Sandy Spring Rural Village Plan: Worksession #1

**Sandy Spring Rural Village Plan:
Worksession #1**

This memorandum provides a summary of the public testimony and the staff response on the Sandy Spring Rural Village Plan. Worksession No. 1 will focus on the general concepts of the Plan including the vision and history; land use, density and height; transportation capacity; and implementation strategies to create a vibrant Village. Worksession No. 2 will discuss any remaining issues and provide a wrap-up.

Request:

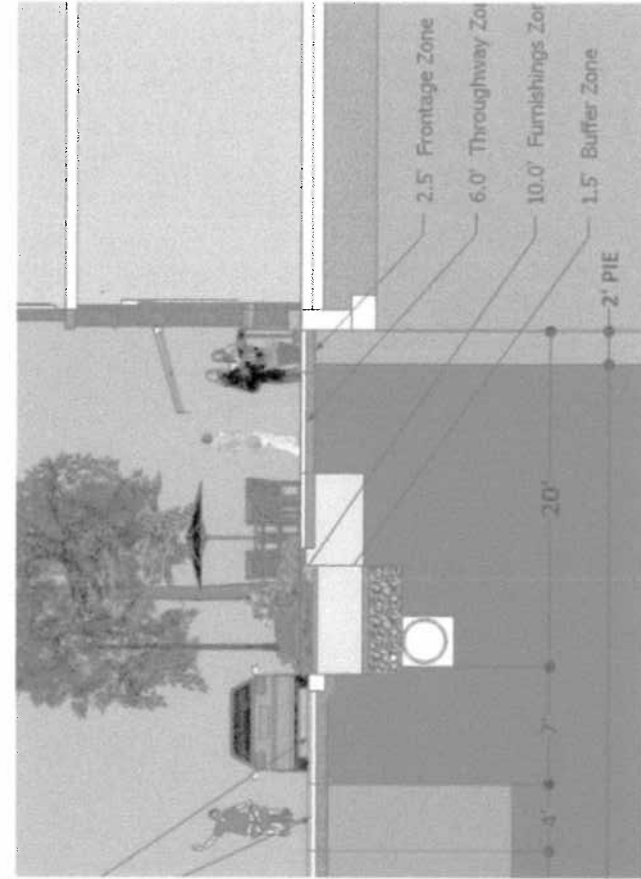
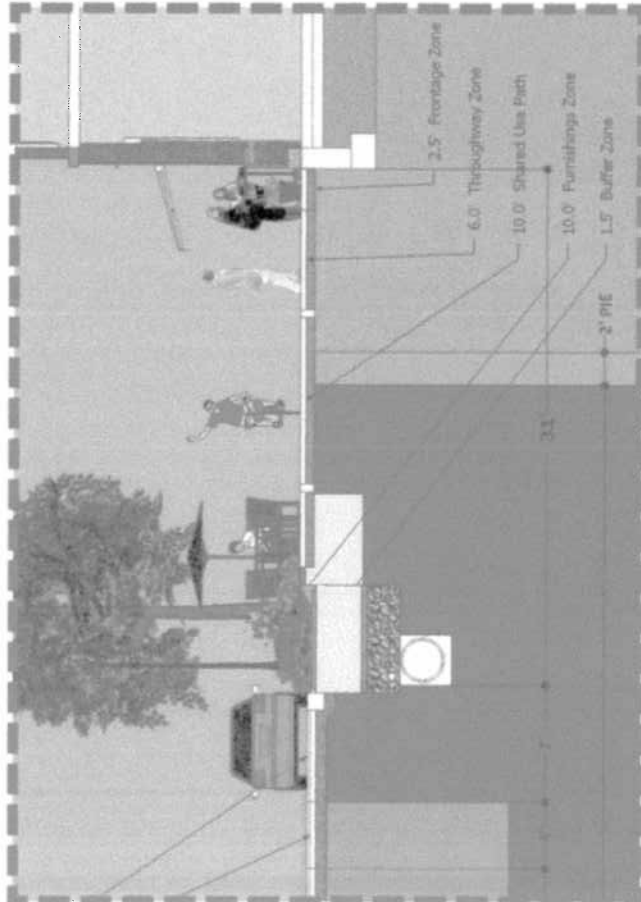
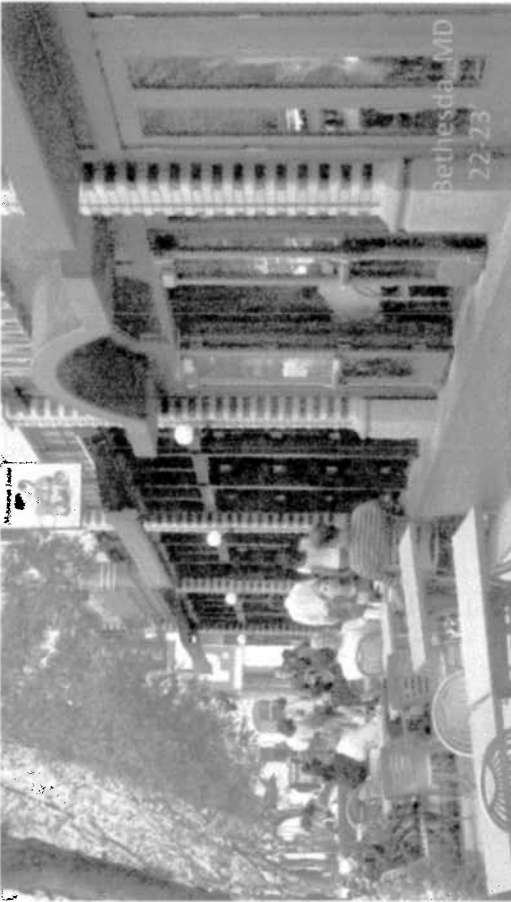
I have attached two sections. The first section, interprets the narrative on pages 35-36. The second section is a suggested alternative that achieves the goals of the draft Plan, but in a way that is in scale with the Village Core.

A few photos of other village center sidewalks, all of which have higher densities and greater pedestrian traffic; none of which have a sidewalk section as large as proposed in the draft Plan.

Provide a context-sensitive solution for the Village Core (from Brooke Road to Skymeadow) that separates the bike and pedestrian traffic in this short area, utilizing the required bike lane and new sidewalk.

If you agree with this approach, we offer the following text changes to the draft Plan:

Sidewalk Section - Village Core

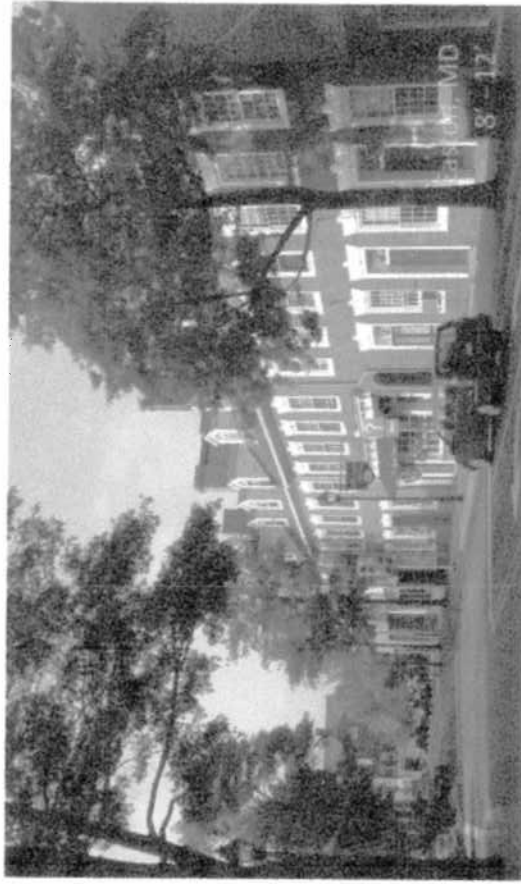
Suggested Alternative

Concept Plan

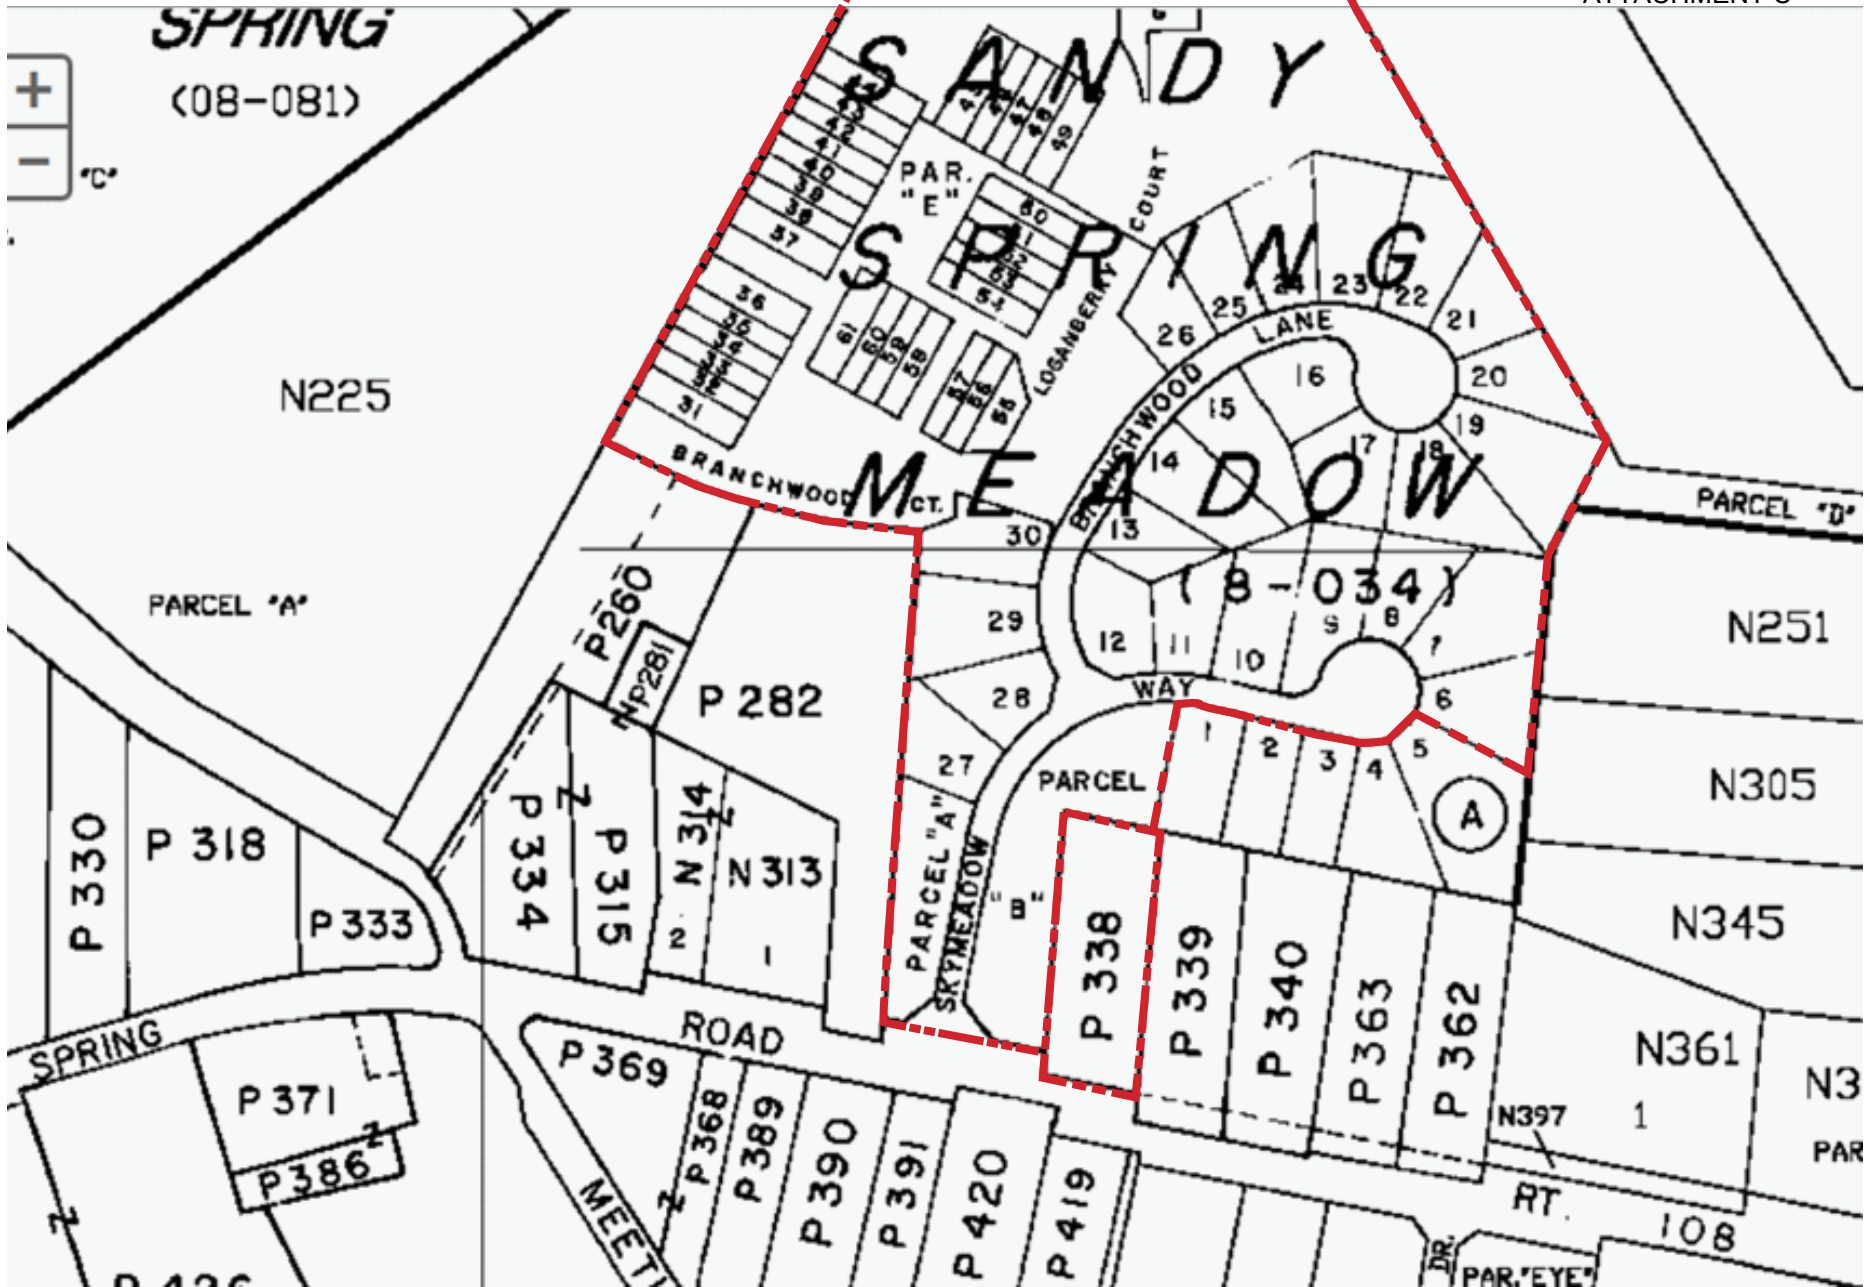
3. **Zoning Along MD 108** – The Housing Opportunities Commission of Montgomery County (HOC) (Jay Shepherd and David Ager) requested to rezone 617 Olney-Sandy Spring Road from R-200 to R-60 and amend the zoning map. HOC is proposing to infill market rate housing into the Sandy Spring Meadow community and requested that the R-200 property at the entrance of Skymeadow Way be rezoned to the same zone as the rest of the subdivision so they can submit a site plan amendment without split zoning.

Zoning Along MD 108	<p>Jay Shepherd, Housing Opportunities Commission of Montgomery County (HOC)</p> <p>Improve Sandy Spring Meadow community by replacing several single-family houses, constructing new townhouses</p> <p>Request R-60 Zoning on Parcel 338 (currently R-200) to fulfill the Plan's recommendation on Page 27: "Provide infill opportunities for additional residential units through the subdivision process"</p> <ul style="list-style-type: none"> Request: Rezone 617 Olney-Sandy 	<p>Staff Response: Amend the zoning map on page 51 to change 617 Olney-Sandy Spring Road from the R-200 to the R-60 Zone. This rezoning will allow this parcel and the adjacent HOC parcel to be combined under one zone (R-60) with one set of development standards.</p>

Staff Response: Rezone 617 Olney-Sandy Spring Road from R-200 to R-60 and amend the zoning map.
